SUBJECT: NuScale Power, LLC Supplemental Response to NRC Request for Additional Information No. 136 (eRAI No. 8933) on the NuScale Design Certification Application

NuScale Supplemental Response to NRC Request for Additional Information eRAI No. 8933

NRC Question No.: 03.07.02-19

NRC Question No.: 03.07.02-20

Figure 3B-48: Elevation View of the NPM Base Support at RXB Pool Floor

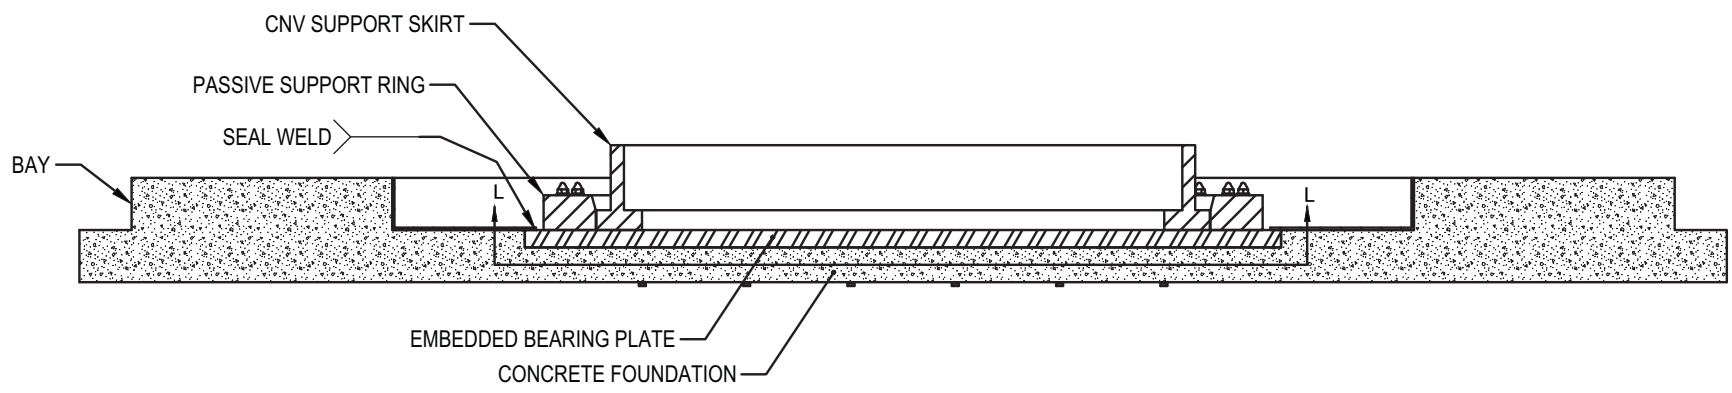
- a. In Figure 3.7.2-28 in the FSAR, the note at the bottom states that the NPM is restrained from horizontal and vertical movements. However, in FSAR Subsection 3.7.2.1.2.2, second paragraph, it is stated that the NPM is allowed to move freely in the upward direction. The applicant is requested to clarify this apparent discrepancy. Also, clarify if vertical lift-off (under tension) of the bottom of an NPM from the pool floor is allowed and, if lift-off is allowed, the applicant is requested to address the effect of potential impact load of the NPM on the liner plate of the pool floor due to vertical seismic motion.

Calculations of NPM lift-off and the floor support design for potential NPM impact loading are provided through the Containment and Ventilation audit.

The NPM floor support design is described in the revised FSAR Tier 2, Appendix 3B.2.7.3 and Figures 3B-48 to 3B-50.

The details of the NPM base support are shown in Figure 3B-48 through Figure 3B-50. The NPM base support ~~is comprised~~ includes of the following:

- The NPM is laterally restrained by ~~a 5" an~~ an 8 in. thick passive support ring made of stainless steel ~~which that~~ is bolted to the underlying bearing plate. welded to the 1/2" thick pool floor liner plate by a 1/2" fillet weld on the inside periphery. At the ~~outside~~ inside periphery of the passive ring, a beveled edge at the top is provided in order to guide the NPM at initial placement and during ~~their~~ its

removal and replacement for refueling operation. ~~In addition to the 1/2" fillet welds, five 2" diameter, 1/2" plug welds (at 15-degree centers located at the azimuths corresponding to the NPM lugs at the higher elevation) are provided at the outer periphery of the passive ring. These plug welds are intended to ensure prevention of potential lifting of the passive ring during removal and replacement of the NPMs.~~ If the NPM impacts the passive support ring, any resulting upward vertical load will be resisted by the concrete anchors. Figure 3B-48 and Figure 3B-49 show the details of the passive support ring.
